Access Compliance Report

Public Rights-of-Way

Intersection ID: 16008	Main Street: SEDGEFIELD_RD	Cross Street: WRISTON_PL	Location: NE
ADA ID: DB813AE7EA97	Ramp Type: Directional1	Initial Pass/Fail: Fail	Overall Compliance: No
			Severity Score: 13.75

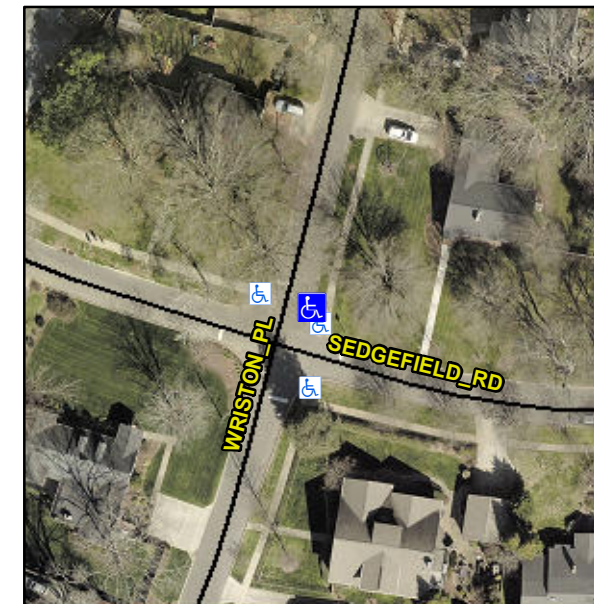
LNDG GAP 1.0"

R304.2.2, R304.5.3

Remove & Replace Entire Ramp.
